E1200535-v12

TMS WORK TO DO LIST GOING FORWARD

6-27-2012

PICTURES OF THE UK AT CALTECH, AND OUR DRAWING NOTE THE GUSSET

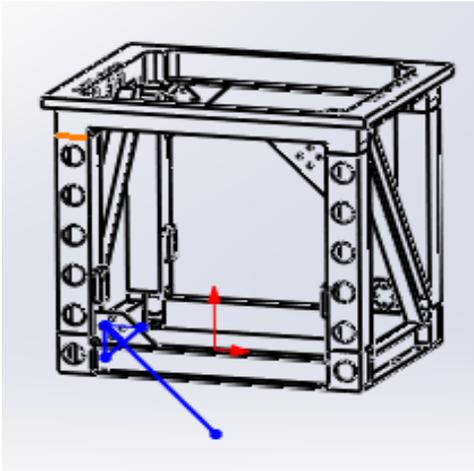
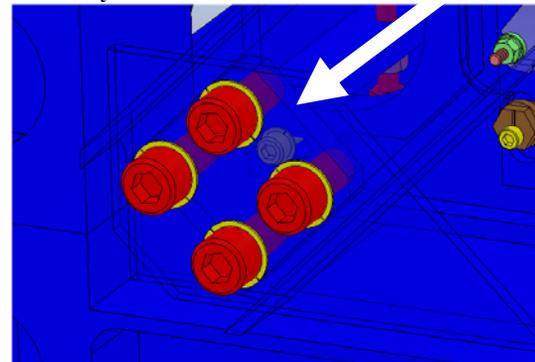
2. D060492 QUAD WELDED FRAME NEEDS TO BE UPDATED IN THE TMS DRAWING AND ASSEMBLIES TO SHOW THE 'UK' STYLE CONSTRUCTION.

THIS CORNER ATTACHMENT FOR THE CHANNEL STIFFENER WELDED IN BRACKET ATTACH POINT (4 PL) RATHER THAN THE NOW SHOWN GUSSET JUST WELDED IN THE CORNER ON THE SURFACE OF THE TUBE.

ACCESS TO THIS SCREW (SEE NOTE ABOVE) NOT needed anymore

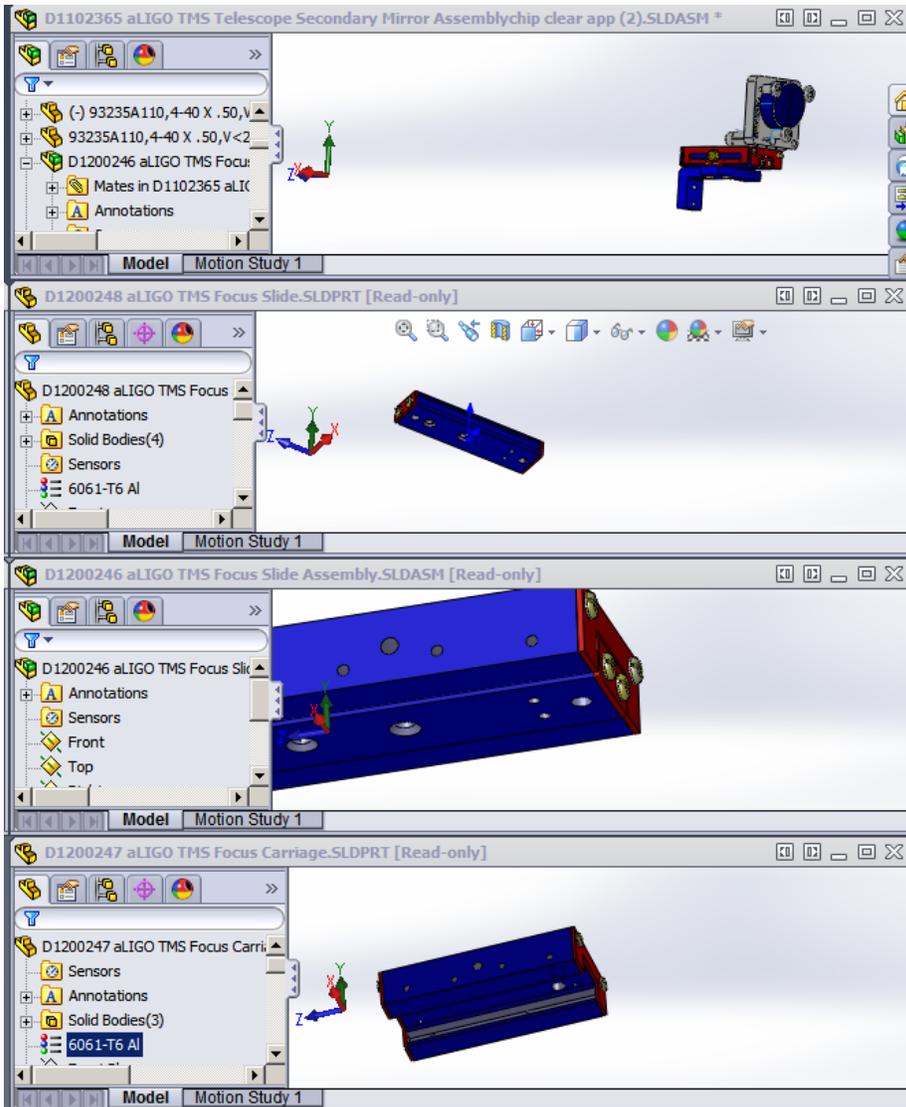
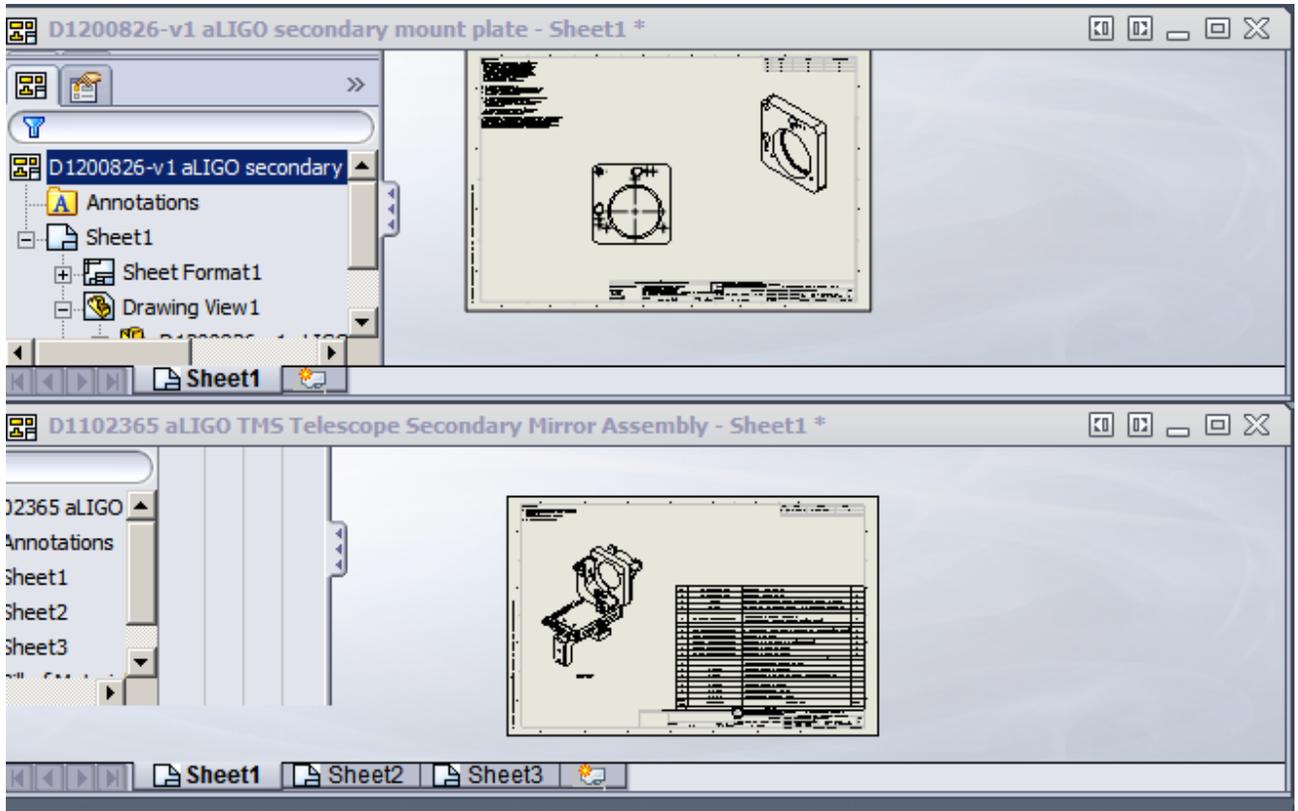
All - Should these parts to be cleaned to class B or wiped down prior to leaving CIT?

Please come up with a plan like the one you mention below and have approved by customers at site.

Calum,
after a good initial cleaning to get the mfg. dirt off,
last time we wiped it, with alcohol, while it was attached to the door, before we
attached it to the flanges.

this assembly is really outside, even more than the arm, it never touches anything in vacuum.
except for the tubes, everything is small, can be put in the sonic bath.
